# Land Development & Transportation Committee

## Staff Report

<b>Case No:</b>	15MISC1006
<b>Project Name:</b>	Redden Mobile Mechanic
<b>Location:</b>	4612 Knopp Ave
<b>Owner(s):</b>	Phil Charmoli, Charmoli-Knopp Properties
<b>Applicant:</b>	Chris Guffey, Allegiant Construction
<b>Representative:</b>	Jason Hall, Prism Engineering & Design Group
<b>Jurisdiction:</b>	Louisville Metro
<b>Council District:</b>	13 – Vicki Aubrey Welch
<b>Case Manager:</b>	Sherie' Long, Landscape Architect

**Attachment 3: Site Plan**

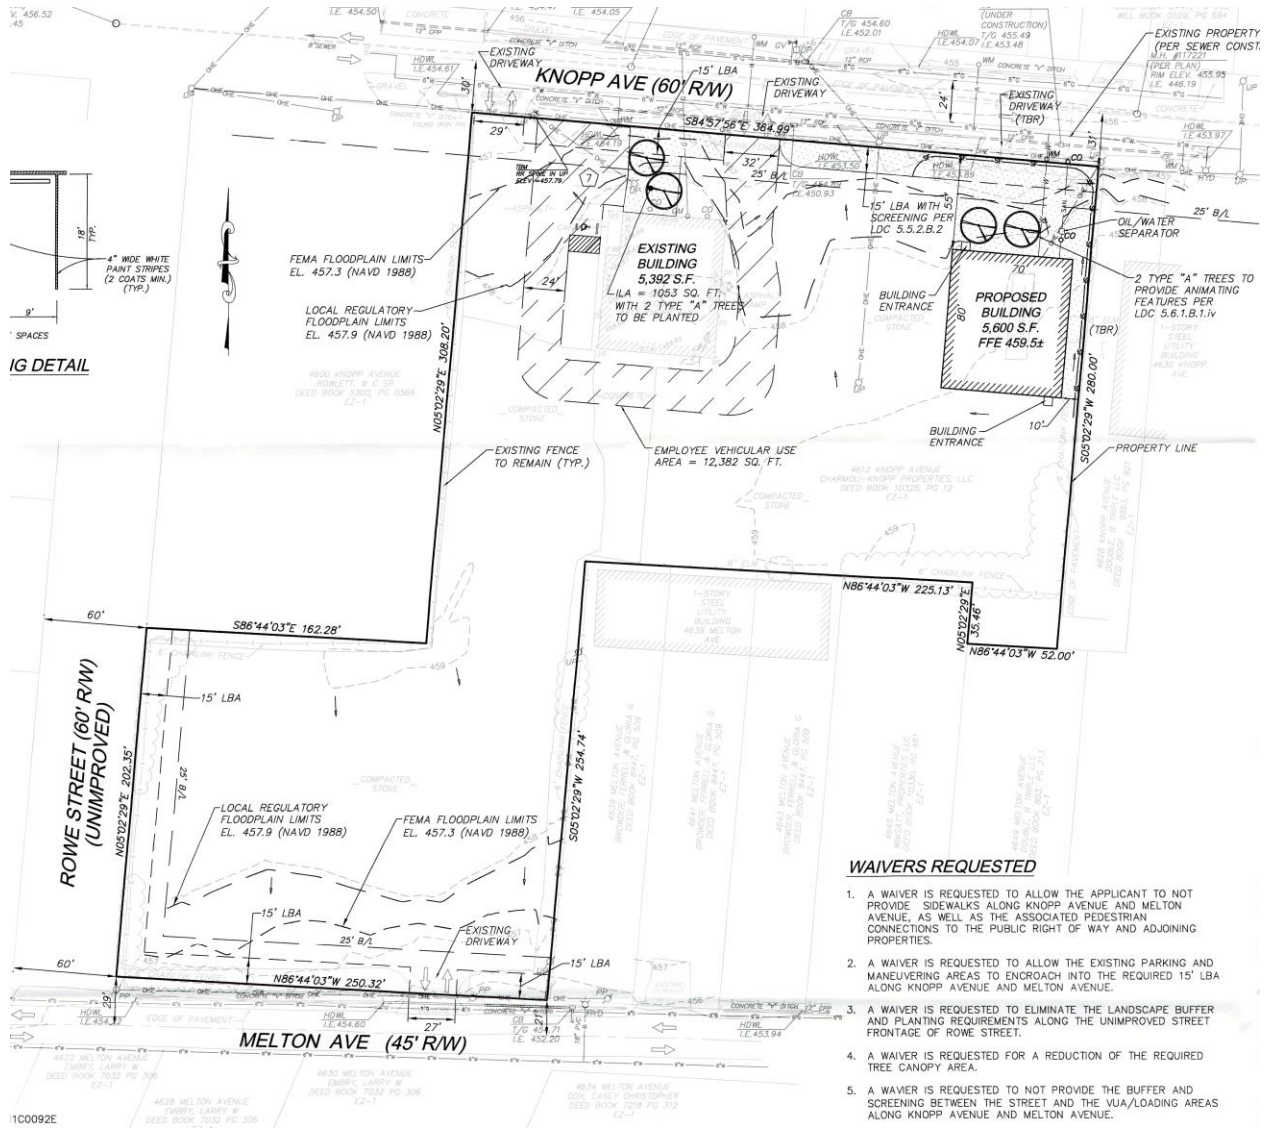
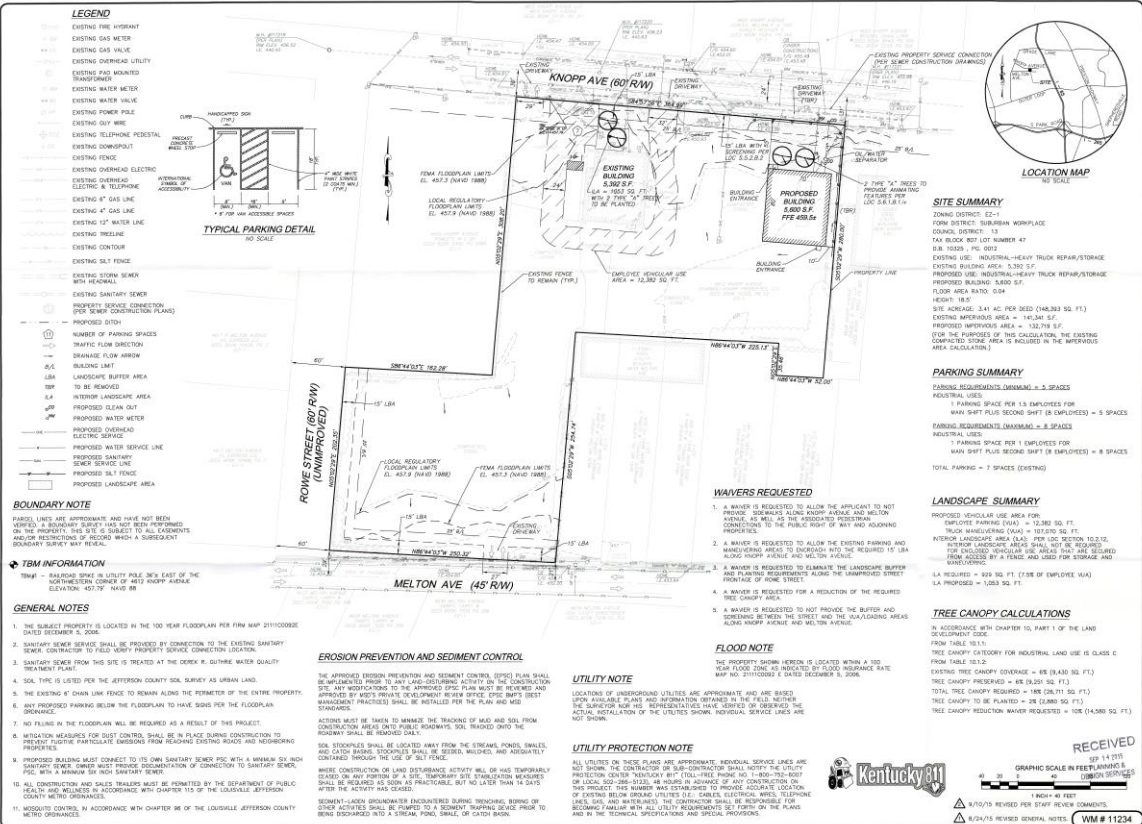
STAFF: The waiver will adversely affect adjacent property owners because the encroachment of the pavement limits the area for the required perimeter planting. This area has been identified by the recently completed tree canopy assessment as an area lacking tree canopy therefore producing extreme heat. Extreme heat does adversely affect health.

STAFF: The extent of waiver of the regulation is not the minimum necessary to afford relief to the applicant since there are no physical restraints preventing compliance with the regulations to be waived. The pavement can be removed to provide the necessary VUA LBA area along the street frontages.

STAFF: The waiver will adversely affect adjacent property owners since the perimeter plantings are not being provided. This area has been identified by the recently completed tree canopy assessment as an area lacking tree canopy therefore producing extreme heat. Extreme heat does adversely affect health.

STAFF: The extent of waiver of the regulation is not the minimum necessary to afford relief to the applicant since there are no physical restraints preventing compliance with the regulations to be waived. The pavement can be removed to provide the necessary area for the tree and shrub plantings to be provided.

STAFF: The extent of waiver of the regulation is not the minimum necessary to afford relief to the applicant since there are no physical restraints preventing compliance with the regulations to be waived.

STAFF: The waiver violates Guideline 13, Policy 5 which calls for standards to ensure the creation and/or preservation of tree canopy as a valuable community resource. The waiver violates the comprehensive plan since the required number of trees are not being provided on or off the site. The applicant has not explored all the alternative options to provide tree canopy. The preservation of

STAFF: The extent of waiver of the regulation is not the minimum necessary to afford relief to the applicant since there are alternative options to fulfill the tree canopy requirements. There are no mitigation circumstances affecting this site. Additional trees can be planted on the site and on an alternative site to fulfill the tree canopy requirements.

1. Identify the existing trees with size and species
2. Modify the plan to reflect the actual square footage of tree canopy existing on the site which was identified during the site visit prior to the public hearing.
3. Adjust the spacing of the four proposed trees.

The three landscape waivers are not supported. The applicant is not providing any buffer plantings beyond the existing invasive vegetation. However, invasive vegetation should be removed and replaced with native species. Invasive vegetation has little or no benefit to the environment.

The tree canopy reduction is not supported. The applicant has not made a good faith effort to provide as many trees as possible on the site, on the adjacent right-of-way, or on an alternative site.
